Environmental Planning Commission

Staff Report

Agenda Number: 2
Project #: PR-2021-005426

Case #: RZ-2021-00045

SITE PLAN REDUCTIONS

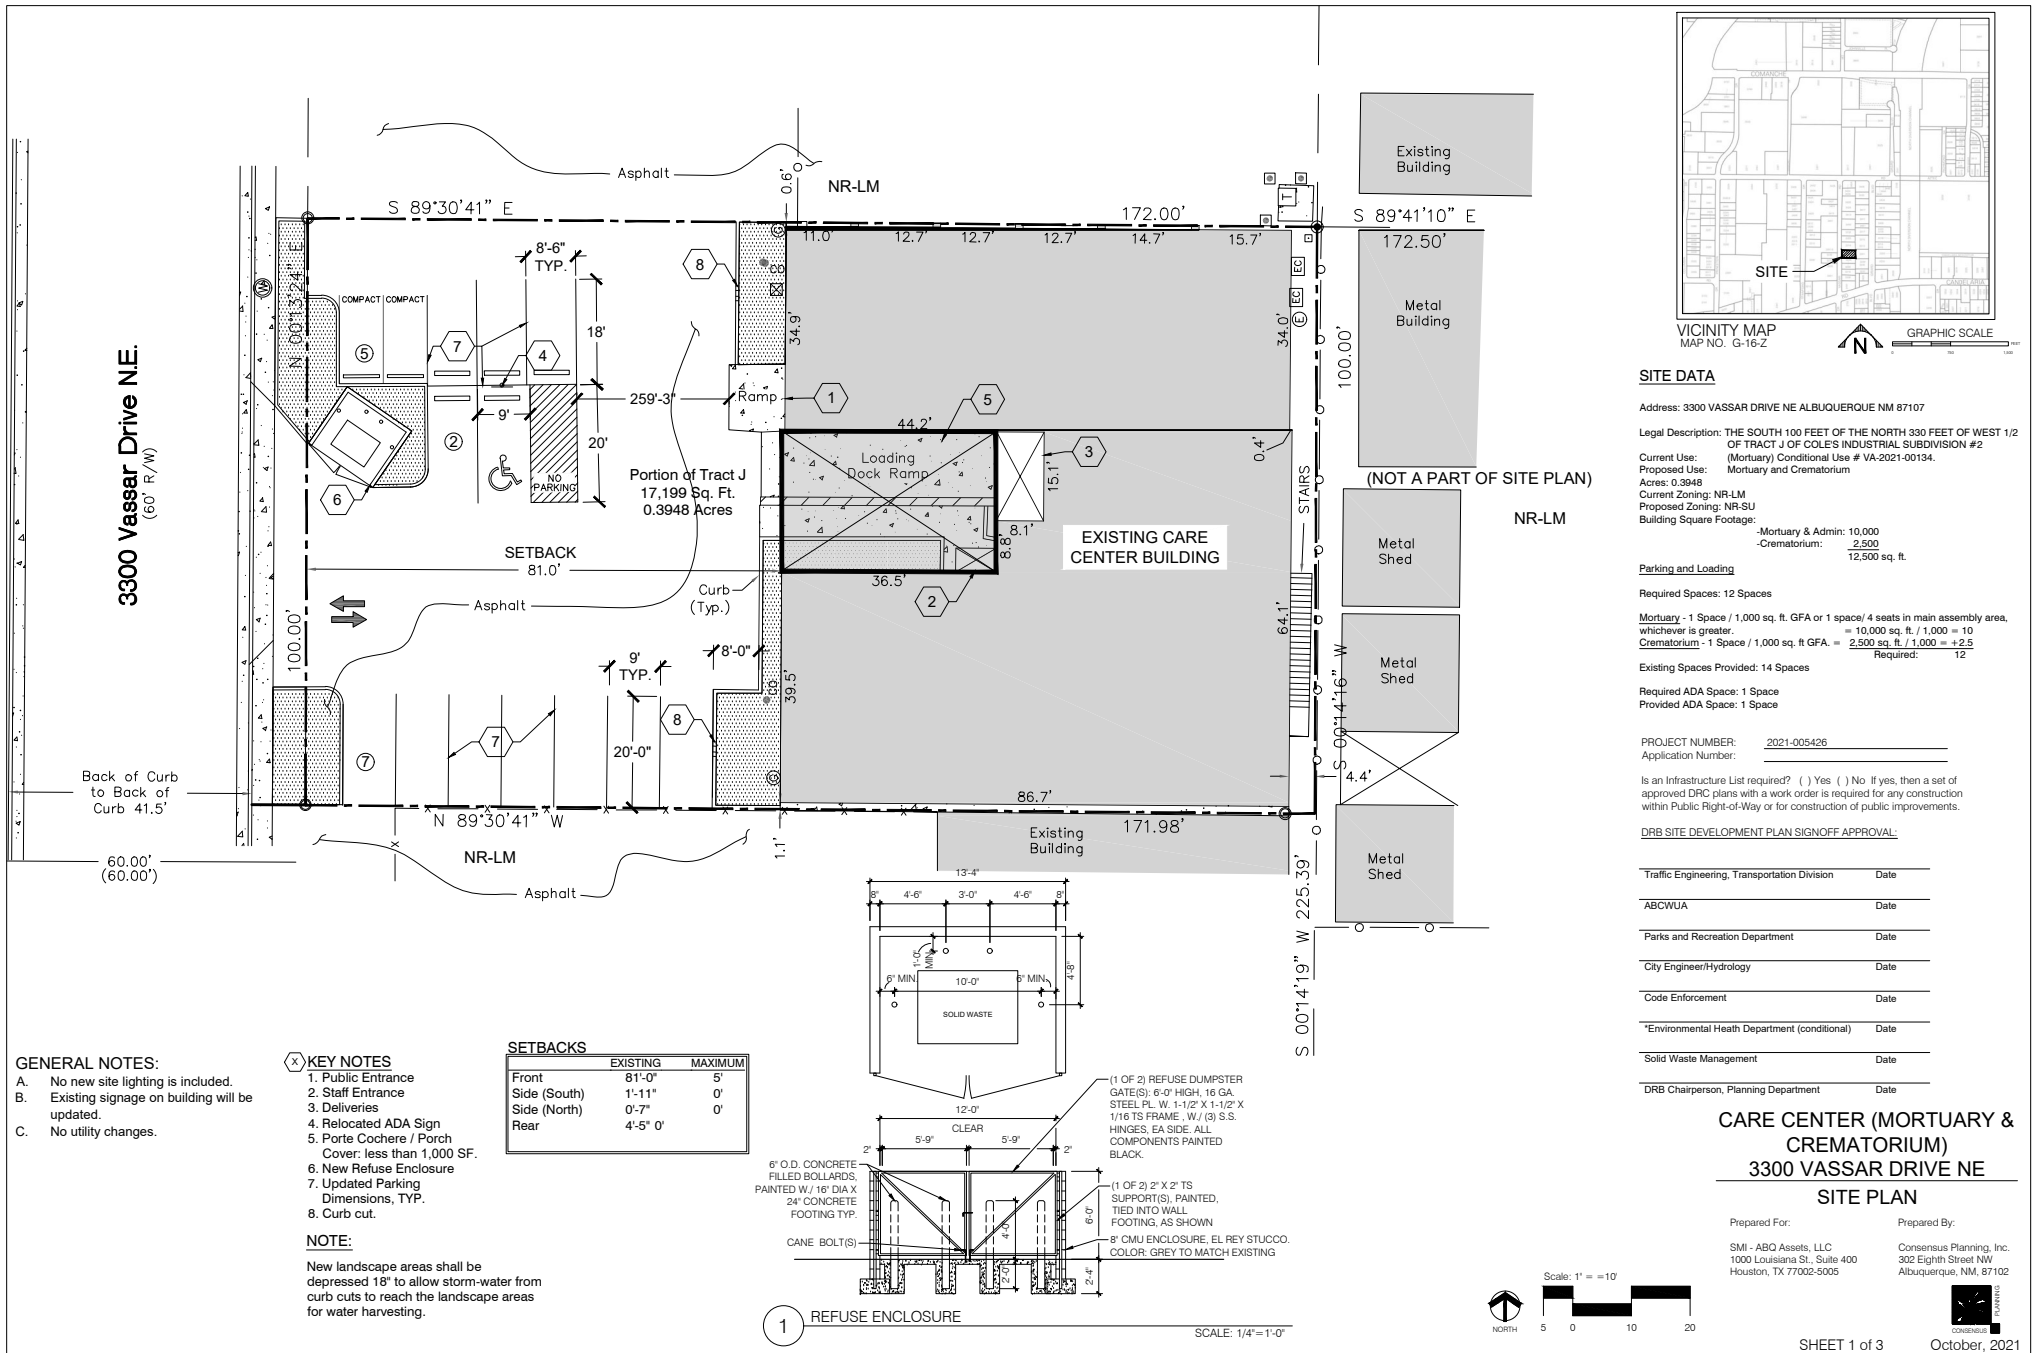
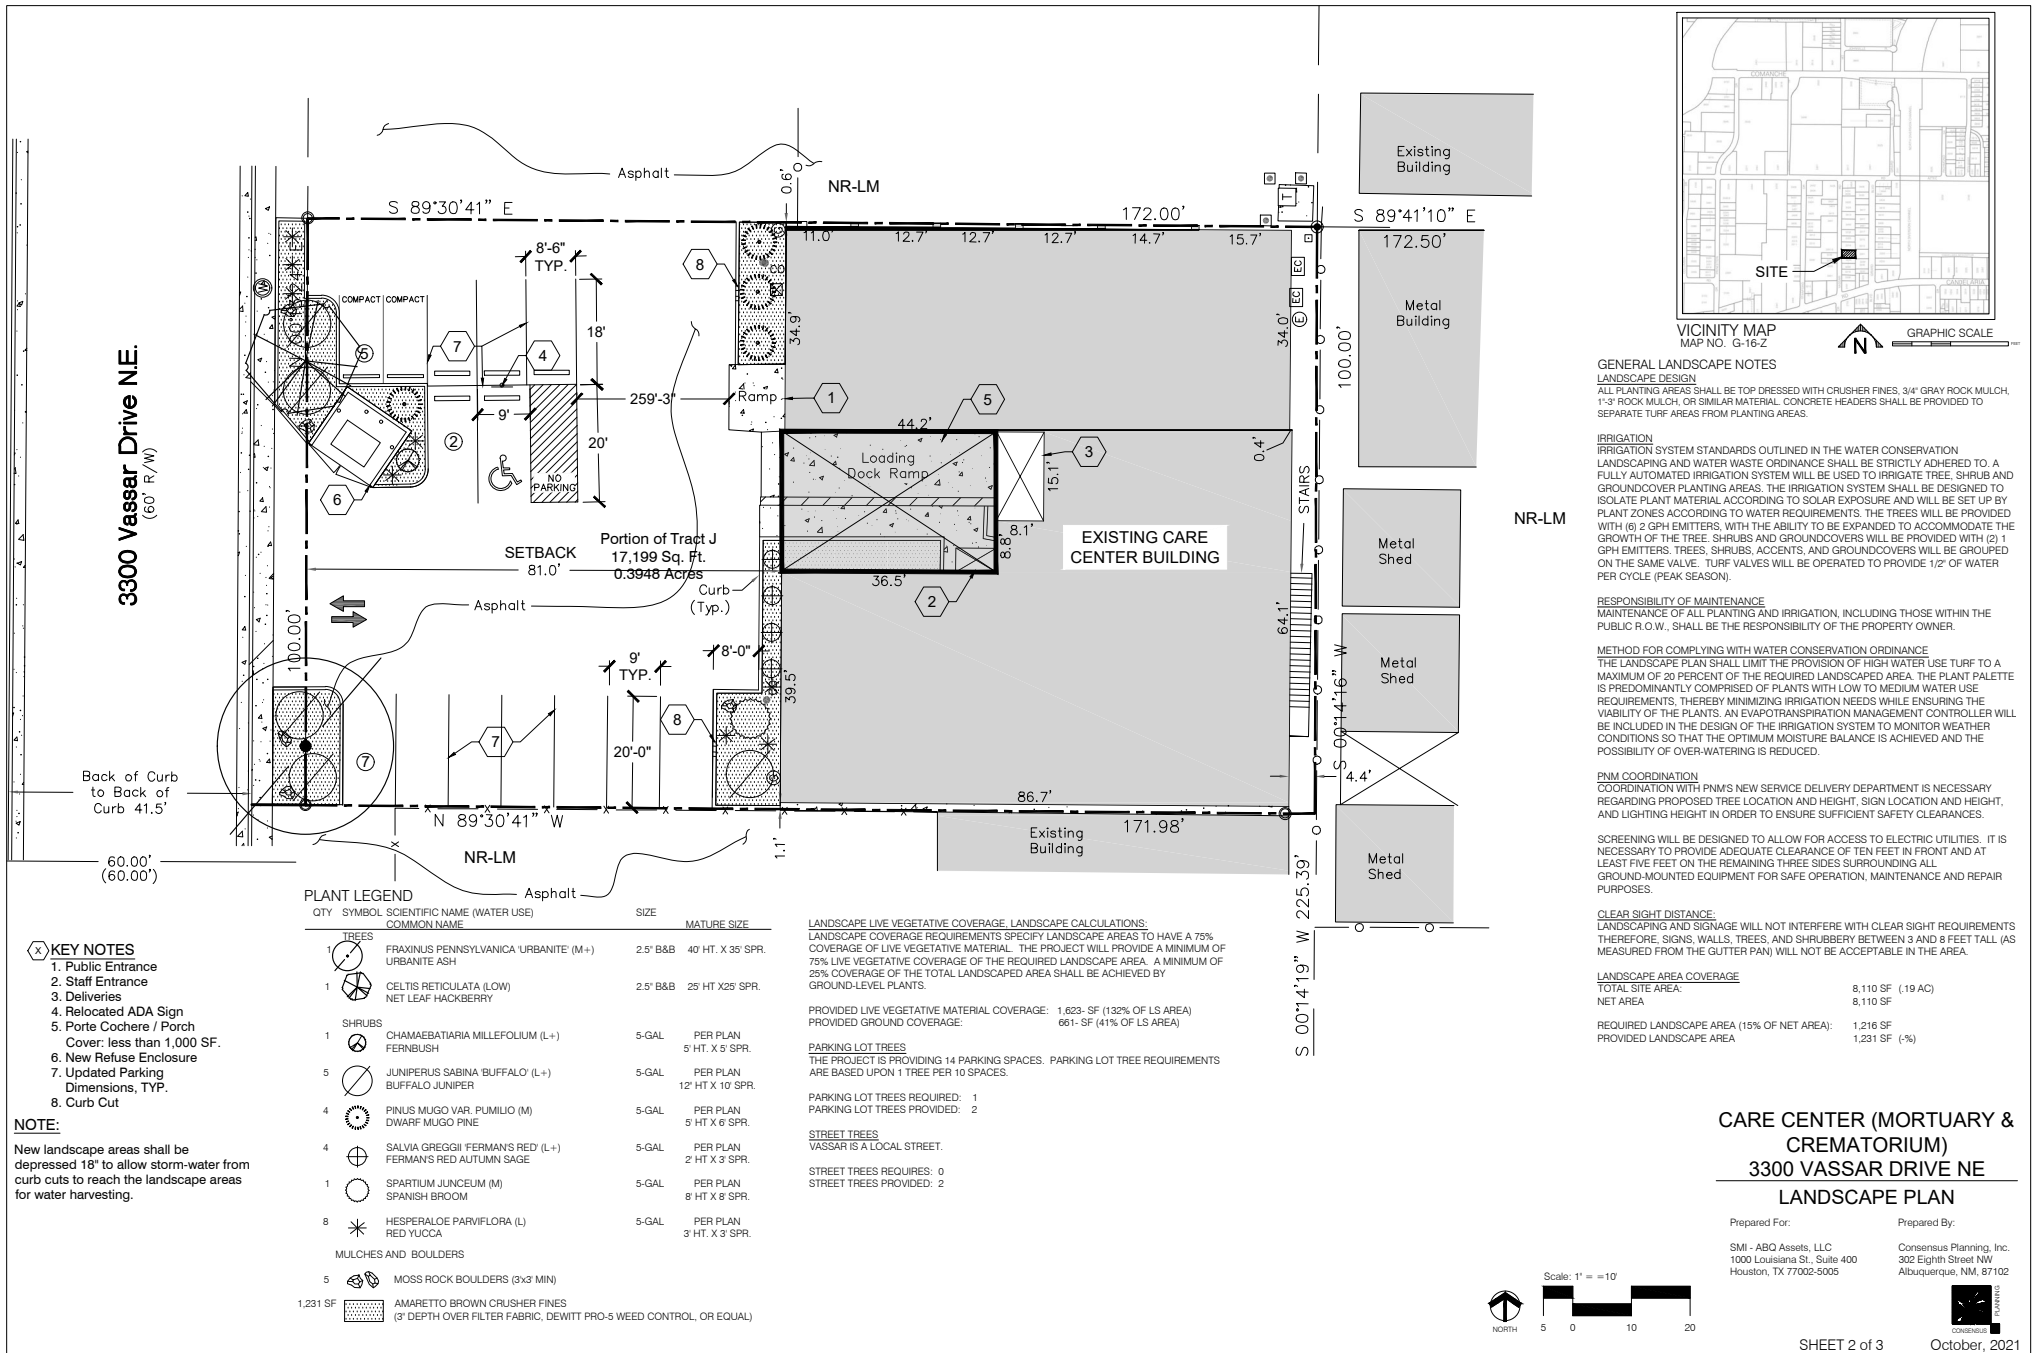
The NR-SU zone standards are established via the Site Plan – EPC review process. The request will not alter the existing building; however, dimensional standards need to be specified on the proposed site plan as required. Building setbacks and maximum height shall be clearly indicated.

The site plan reviewed here does not contain sufficient information or clarity to determine which standards are met and which are proposed to be varied from. A clean and efficient way to do this is by doing a summary table (see table 2-5-9) and by including sufficient notes on the site plan.

The IDO requires motorcycle parking pursuant to IDO subsection 5-5(D), and bicycle parking pursuant to IDO table 5-5-5. Neither are shown on the site plan; nor is it clear that the applicant is requesting to wave these requirements.

The required on-site pedestrian connections are not provided. The applicant shall update the site plan to show required pedestrian connections pursuant to IDO 5-3(D)(3) On-site Pedestrian Connections, or request that the EPC wave the requirements.

No new lighting is proposed. However, existing lighting needs to be clearly shown on the site plan.

The site plan includes landscape calculations, however there are discrepancies in the total site area. The site plan shows the site area at .39-acres and the landscape plan shows the total site area at .19-acres. The drawings need to show the correct total site area and which IDO provision they are using to determine the appropriate landscaped area, i.e., pursuant to IDO subsection 5-6(C)(2) the minimum landscaped area shall be 15% of the net lot area.

The landscape plan shows a selection of seven plants consisting of different trees and shrubs. Only female Buffalo Junipers shall be used for landscaping. No turf is shown; language discussing the amount of watering for turf shall be removed or the turf shall be clearly shown on the landscape plan.

The applicant provided two photographs in lieu of elevation drawings, with estimated heights. The applicant shall clearly show elevations of what the building is proposed to look like after the renovations (any changes to doorways), and clearly label colors and materials on the elevations, as well as dimension building elements. Pursuant to IDO subsection 5-6(G)(1), all mechanical equipment shall be screened, proposed mechanical and screening shall clearly be shown on elevation drawings.

The applicant notes that there will be new signage, but does not clearly show what the signage will look like, or what type of signage will be used. Any proposed signage shall be clearly shown on elevations or in a detail drawing. Pursuant to IDO table 5-12-2, all signage standards for the NR-SU standards are determined via the approved NR-SU plan, which is being considered here.

A site plan to scale approved for access will be required by the Solid Waste Department. The trash enclosure will have to meet City of Albuquerque minimum requirements. An apron to the trash enclosure will be required. Landscape plan—The proposed Urbanite Ash (tree) will have to be relocated. It cannot overhang the trash enclosure.
